TO: Mercedes-Benz Principals, General Managers, Sales Managers, Service Managers, Parts Managers	FROM: Anthony Washington, Department Manager, Regulations and Certifications
Re: Recall Campaign Launch Notification Model 447 (Metris) Model Years 2017-2022 Check and Replace Fuel Hose Clamps and Hose	DATE: April, 2022

SUBJECT: **Model 447 Metris, Model Year 2017-2022**
Check and Replace Fuel Hose Clamps and Hose

SM47.25-S-0028A **Check fuel hose to fuel line of service connection for proper fastening, replace if necessary (code: VS2KRAUCH)** **25.03.2022**

S47.25-A006-09

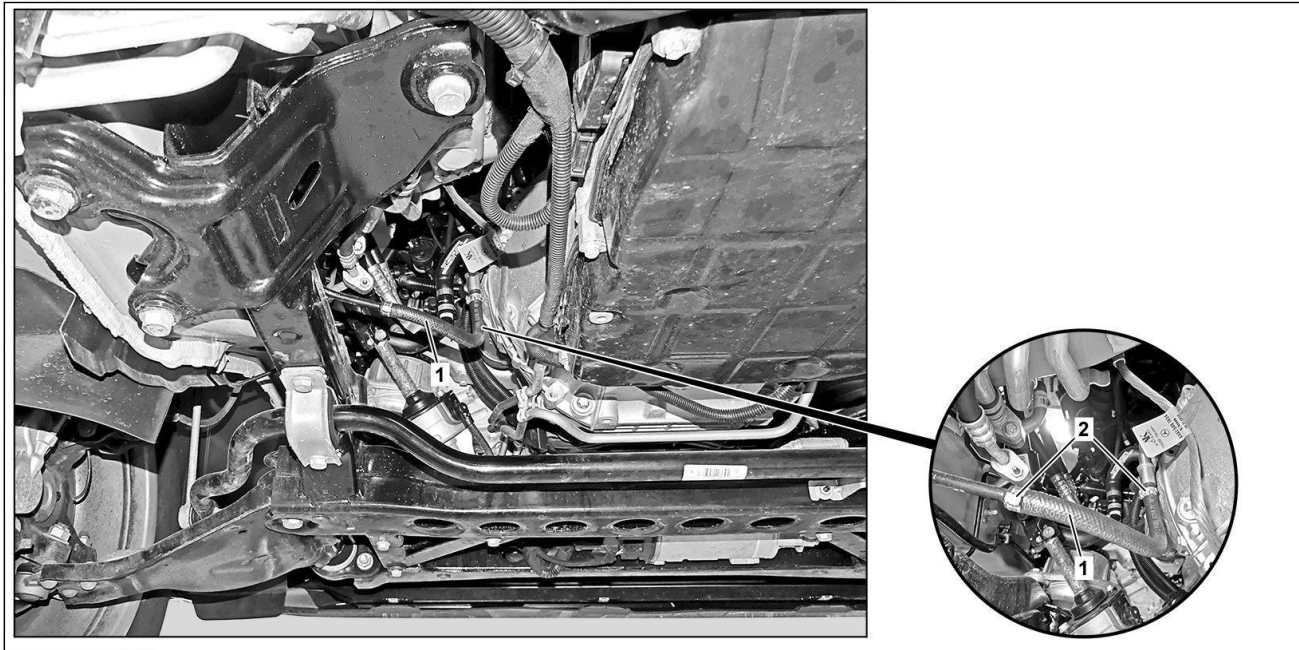
Check		
4	Check fuel hose to fuel line of service connection (1) in area of click clamps (2) for damage and fuel coating.	If the fuel hose to the fuel line of the service connection (1) is damaged or coated with fuel, ↓ continue with operation step 5. If there is no problem with the fuel hose to the fuel line of the service connection (1), ↓ continue with operation step 8.	
	Replace		
5 	Remove fuel pressure via the service connection.	 Dust protection cap to service connection 	AR07.03-S-1460-04EG BA07.03-Z-1001-01KOH 119 589 04 63 00
6	Replace fuel hose to fuel line of service connection (1) and click clamps (2).	Only if the fuel hose to the fuel line of the service connection (1) is damaged or coated with fuel.  Collect escaping fuel in a suitable container and seal connections.  Dispose of removed component parts properly. To do so, observe the applicable legal requirements and specifications of the relevant country.  Record plug  Pliers for click clamps	129 589 00 91 00 171 589 00 37 00

Part no.	Designation	Quantity
A 006 997 18 90	Click clamp, fuel hose to fuel line of service connection (as per findings)	n. B.
N 000000 004158	Fuel hose to fuel line of service connection (as per findings)	n. B.
